Dresden Nuclear Power Station, Units 2 and 3
Facility Operating License Nos. DPR-19 and DPR-25
NRC Docket Nos. 50-237 and 50-249

Quad Cities Nuclear Power Station, Units 1 and 2
Facility Operating License Nos. DPR-29 and DPR-30
NRC Docket Nos. 50-254 and 50-265

Subject: Additional Plant Systems Information Supporting the License Amendment Request to Permit Up-rated Power Operation at Dresden Nuclear Power Station and Quad Cities Nuclear Power Station

Additional Plant Systems Information Supporting the License Amendment Request to
Permit Uprated Power Operation (non-proprietary version)

Figure 2
Dresden and Quad Cities Short-Term DBA-LOCA
Containment Pressure Response

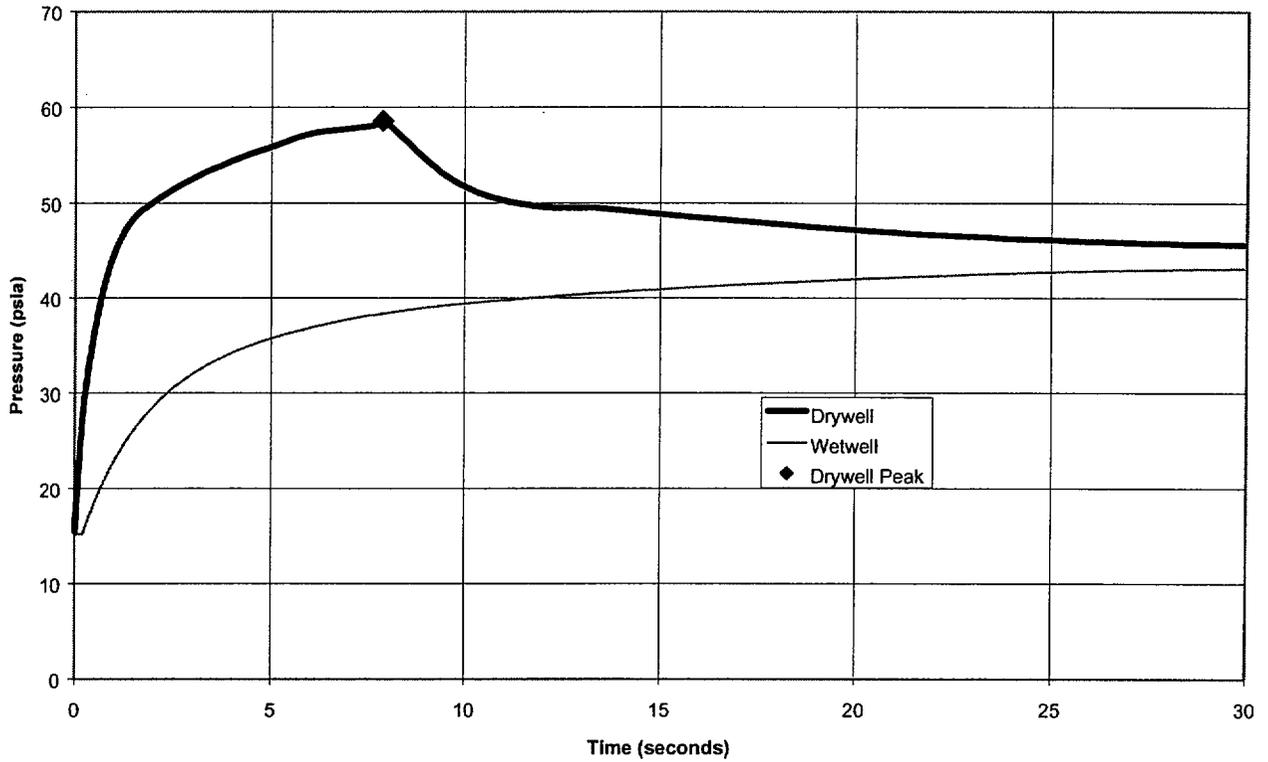
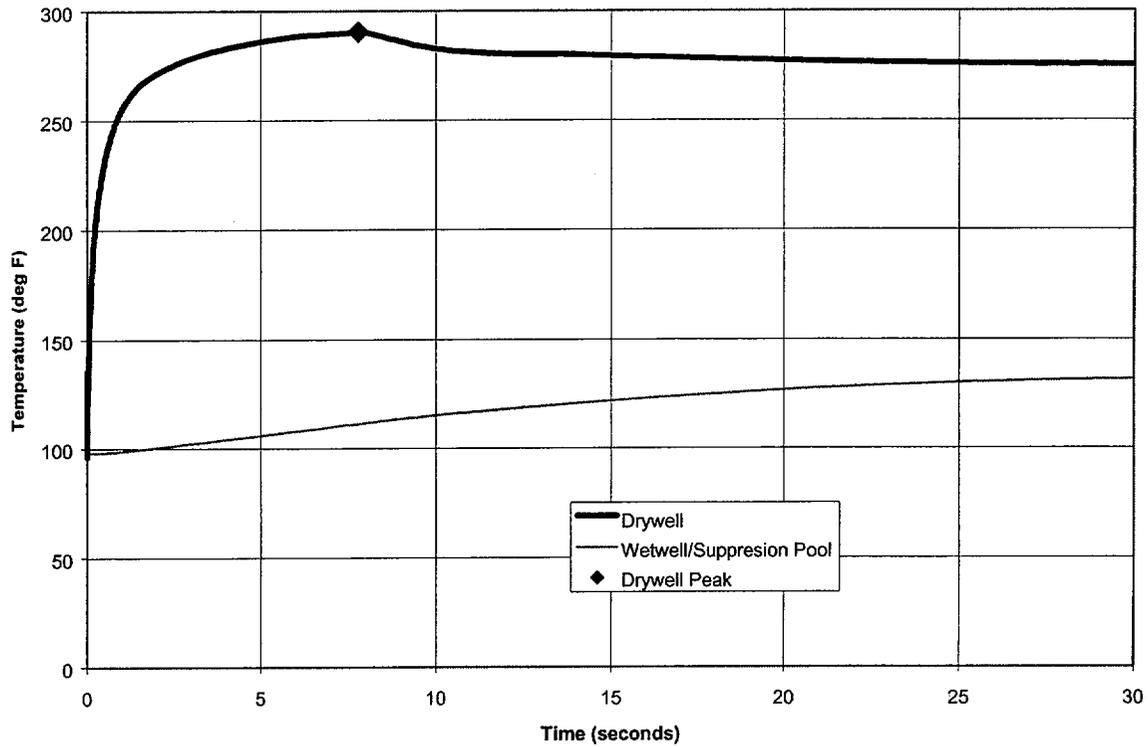
6. Provide short term and long term results (curves or tables of calculated values as a function of time) of calculations for

Drywell short term pressure and temperature are provided in Figures 2 and 3. Suppression pool short term temperature is provided in Figure 3. Wetwell atmosphere short term pressure and temperature are provided in Figures 2 and 3. Suppression pool long term temperature is provided in Figures 5 and 9. Wetwell atmosphere long term pressure and temperature are provided in Figures 4,5,8, and 9. Notes for the figures are provided in Table 1.

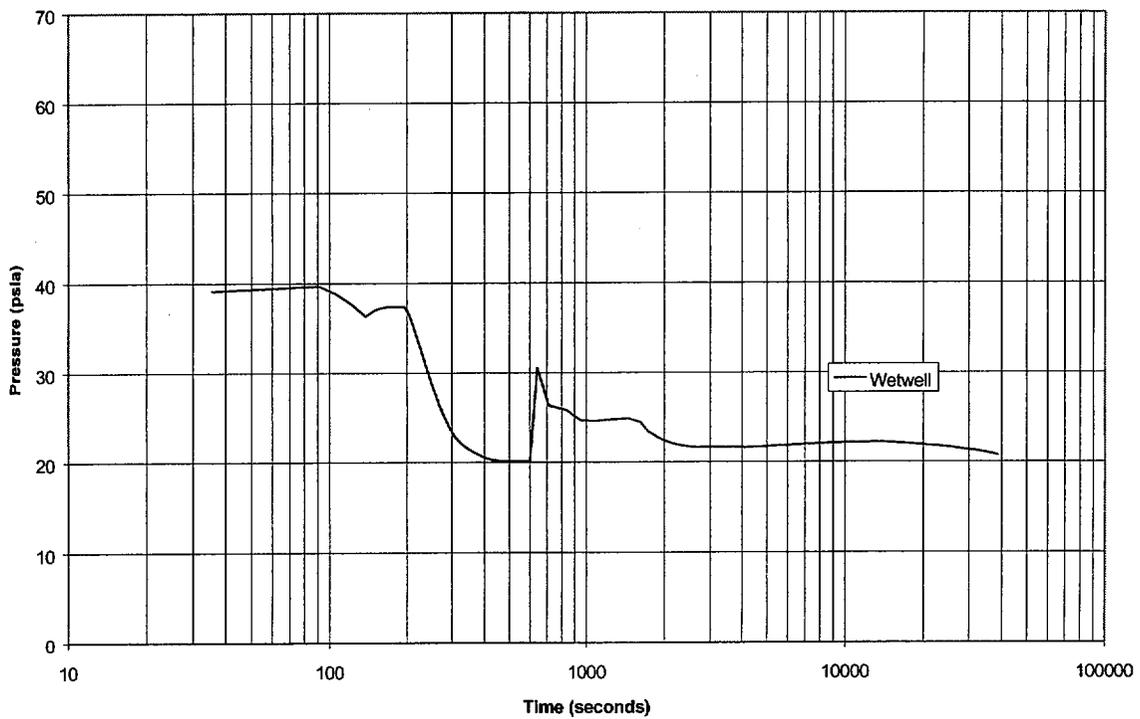
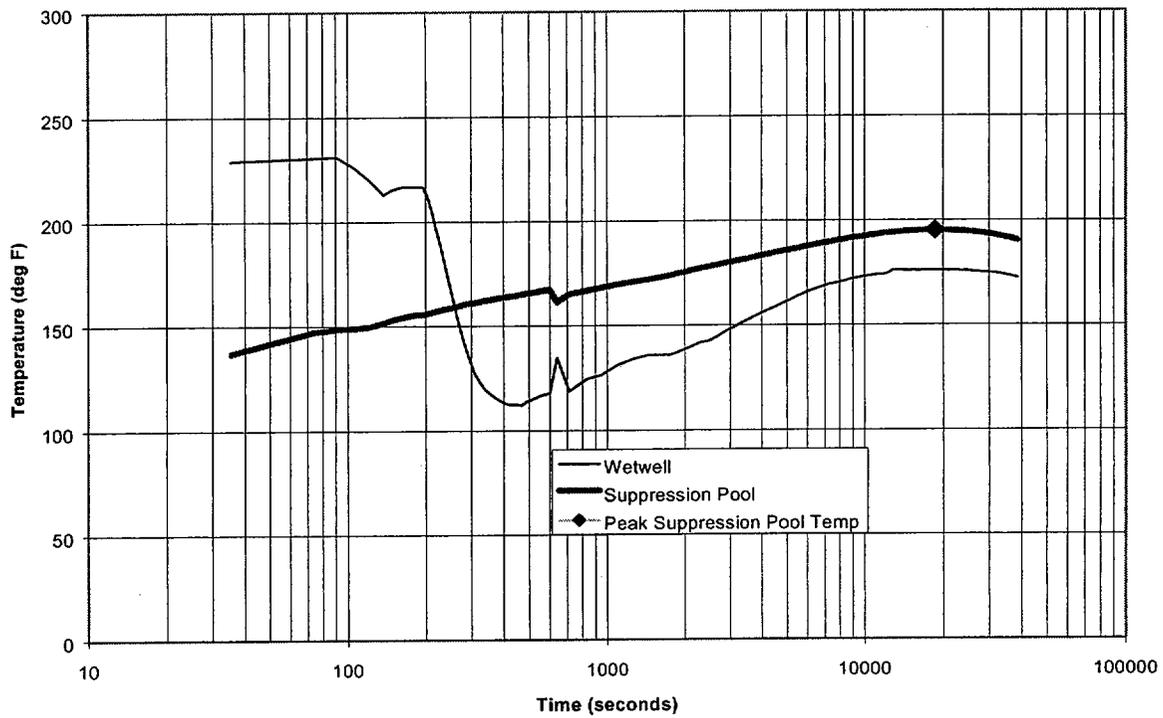
If the long term calculation results are different from those used for calculating NPSH, provide the suppression pool long term temperature and wetwell atmosphere long term pressure and temperature used for the NPSH calculation.

Figures 6,7,10, and 11 provide the curves showing the wetwell atmosphere pressure and temperature and the suppression pool temperature used for the net positive suction head (NPSH) calculation. As noted in Table 1, appropriate assumptions were used to minimize the containment pressure available and maximize the required NPSH.

Figure 12
Hydrogen Generation Rate in Containment Following Loss of Coolant Accident

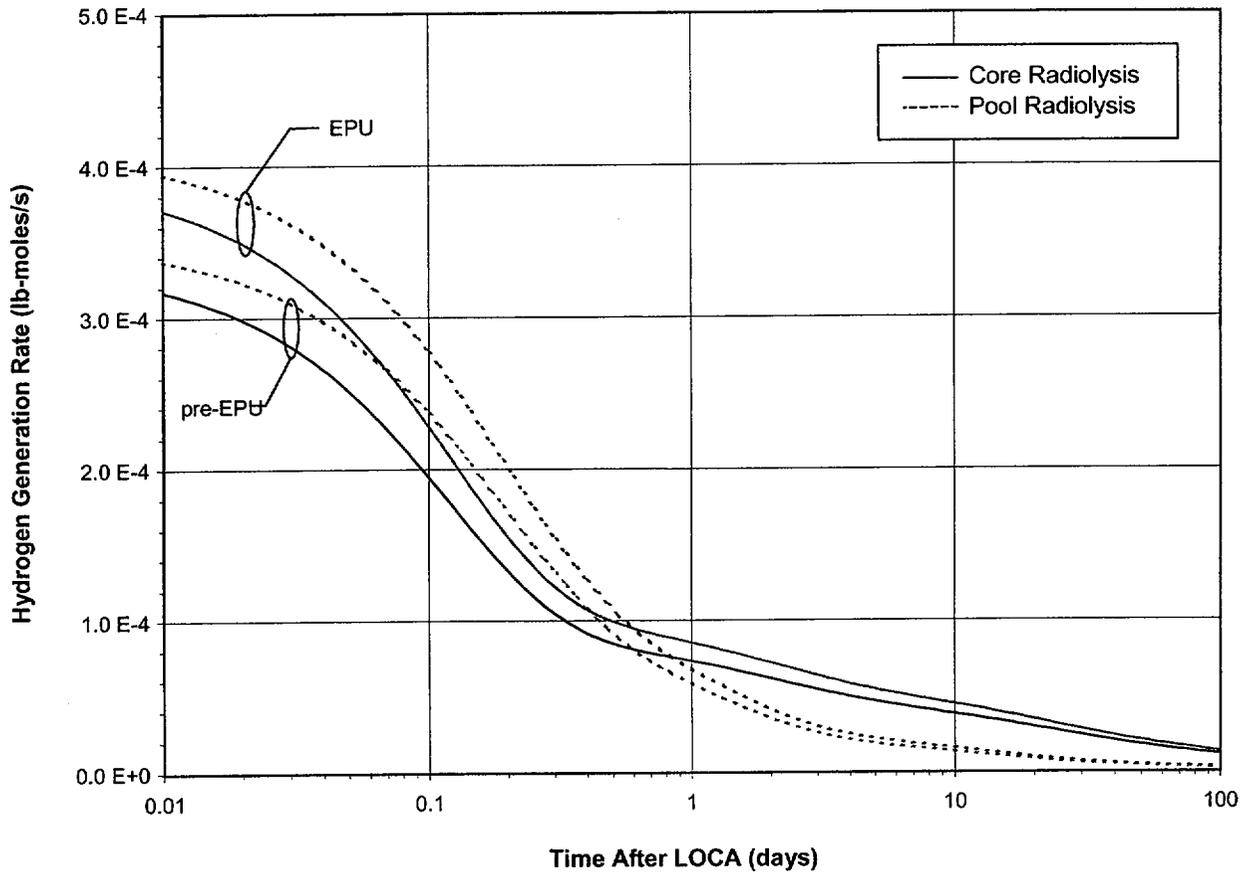
12. Section 4.7 on post-LOCA combustible gas control notes margin changes in various parameters associated with the EPU and additional impact of GE14 fuel introduction on metal-water hydrogen production. Provide long term results (curves or tables of calculated values as a function of time) of calculations for

Hydrogen production is provided in Figure 12. Oxygen production is not specifically presented, but equals one half of the hydrogen production.
